# A1 Birtley to Coal House

## Scheme Number: TR010031

**Responses to Deadline 5 submission from other parties - Historic England - Appendix 2A - Consultation with Lee McFarlane, Historic England**

# AGENDA & MEETING NOTES

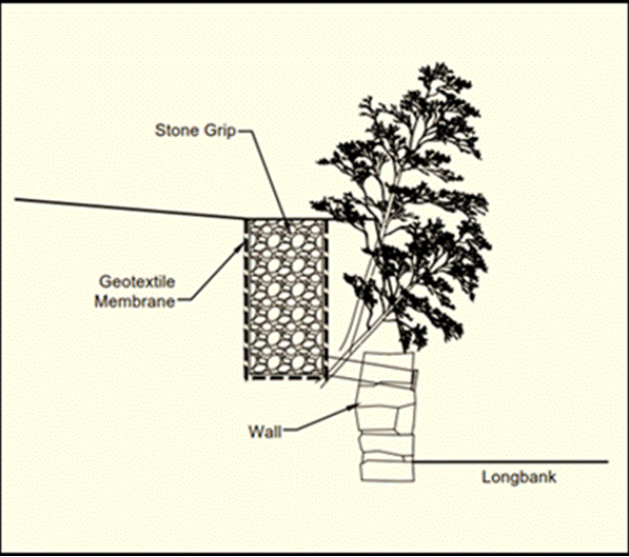
Regarding the drainage drawing below. Does it show the grip being near the top of the wall? I would worry that there is potential for water damage down the face of the wall (and ultimately cause mortar loss/water ingress into the structure) if it is this high up? Could it be lower perhaps?

ITEM	SUBJECT	ACTION	DUE
	<p><b>Drainage grip behind the retaining wall</b></p> <p>The sketch detailing the drainage grip behind the retaining wall provided by WSP via email on 15 May 2020 was discussed.</p> <p>3 ■ questioned how much water would be expected to travel through and the expected associated damage to the wall. ■ discussed that the responsibility for future maintenance of the drainage would be Highways England.</p> <p>Action: ■ to clarify with the drainage engineers the level of water that would be expected to go through the wall and what impact the water would have on the wall.</p>	■	01 June 2020
	<p><b>Outline CEMP [CH2]</b></p> <p>4 ■ discussed the wording of “substantially in accordance with” in [CH2] of Table 3-1 REAC the Outline CEMP. It was discussed that Historic England will be consulted on the final WSI and any should Historic England have any concerns that these would be raised with the Secretary of State (SoS). She further discussed that the Scheme will need to demonstrate that any changes to the documentation i.e. in the final CEMP and WSI, do not cause any worsening of effects and that Highways England has an “evaluation of change” process that ensures this is the case. ■ discussed that this wording would remain unchanged in the Outline CEMP being submitted at Deadline 6 (19 May 2020).</p> <p>Action: ■ to seek guidance from Historic England’s legal advisor on this wording.</p>	■	01 June 2020

I have also provided below the likely detail of the drainage grip behind the retaining wall for your information / further discussion.
